EH-PLANS-26-0

EnvHealth/Environmental Health/Plan Check/Application

SFD/ CONSTRUCT 24' x 24' Detached Garage, 0 STORY, Slab on Grade, 0R, 0FB, 0HB, 0FP, OTHER STRUCTURE = Detached Garage, 0BR, PORCH/DECK = N/A, ENERGY METHOD = N/A,

☐ Primary	<u>Street # (start)</u>	<u>Direction</u>	<u>Street Name</u>	<u>Street Type</u>	<u>City</u>	<u>State</u>	<u>Zip Code</u>	<u>Address Status</u>	<u>Street Suffix (Direction)</u>	<u>Unit Type</u>	<u>U</u>
☒	13309		Hunt Ridge		Ellicott City	MD	21042

REVISED

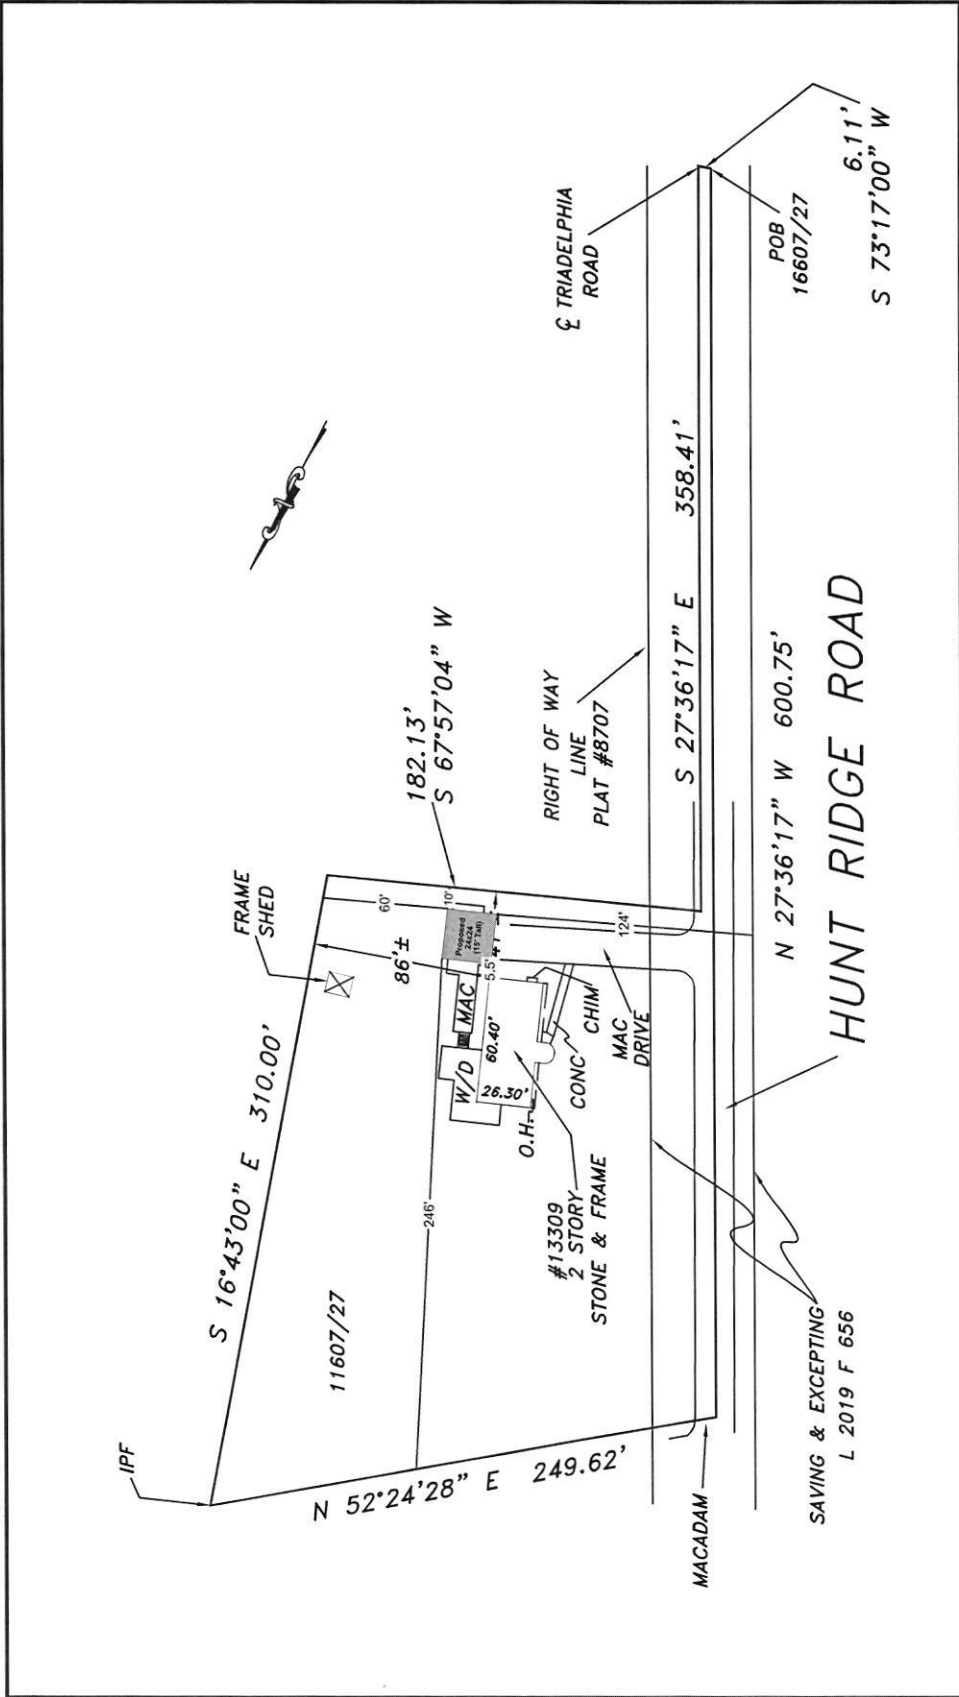
Please remove the distance line & measurement shown from the well to garage and show the distance from the closest corner (back left) of the garage to the septic trenches. Thanks again.

Good afternoon Jessica,
As discussed earlier today, please revise the site plan to show the well & septic components on the property and the distances from the septic tank & septic area (SDA) to the proposed garage. Once uploaded to the online permits portal please let me know and I will review it as soon as possible. Hope you have a wonderful day and let me know if you have any questions. Thank you kindly!

I revised the site plan per your notes below and re-uploaded it to the portal labeled "Mi Dennison - 2290159 Revised V3.pdf"
